Serial No.: 09/687,886

For: METHODS AND APPARATUS FOR ROTOR
OVER-SPEED PROTECTION

SUBMISSION OF MARKED UP CLAIMS

FIG. 4

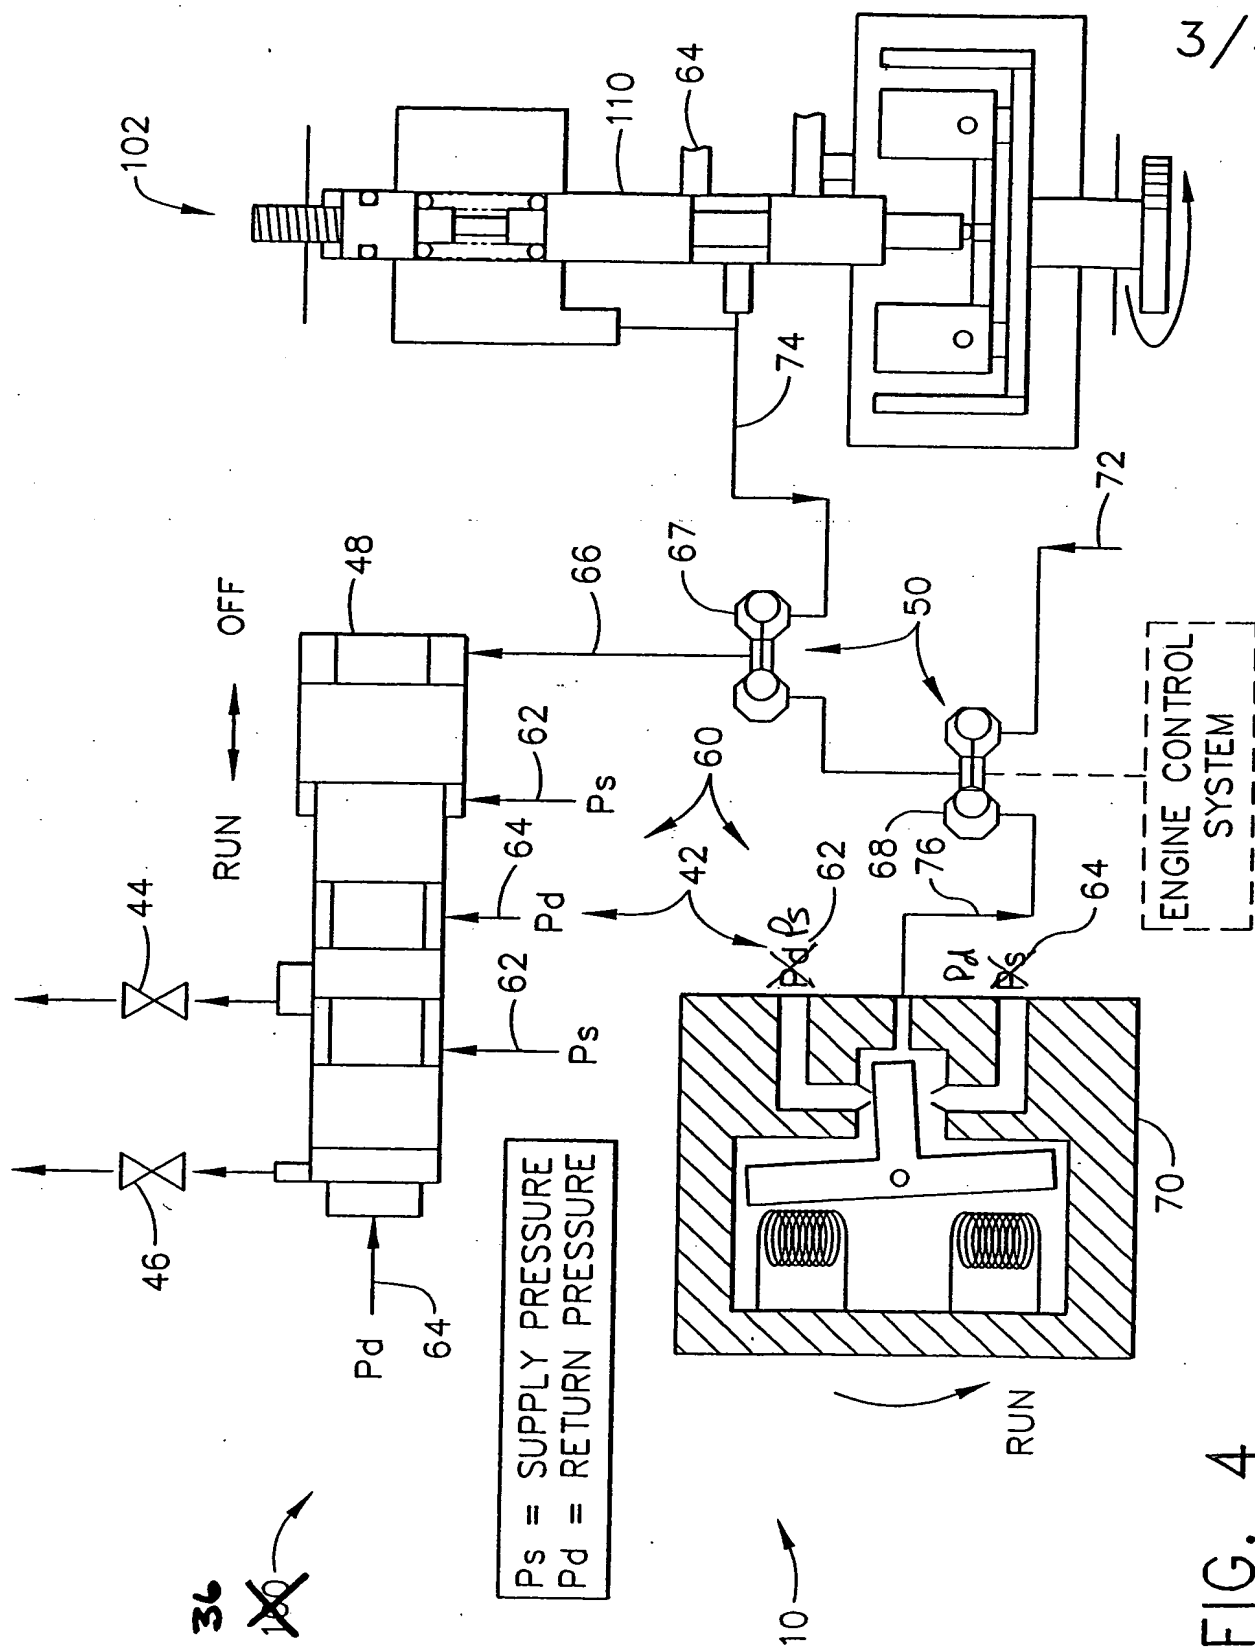
The objection to the drawings under 37 C.F.R. 1.83(a) is respectfully traversed. Submitted herewith is a Request for Approval of Drawing Changes. Specifically, Figures 2, 4, and 5 have each been amended to exchange respective reference characters Ps and Pd adjacent aircraft control shutoff valve 70. Furthermore, Figures 2 and 5 have also been amended to change the direction of the flow arrow within line 66 to point upwardly. Upon approval of the drawing changes, Applicant will submit substitute formal drawings incorporating the above-noted change. No new matter has been added. For the reasons set forth above, Applicant respectfully requests the objection to the drawings be withdrawn.
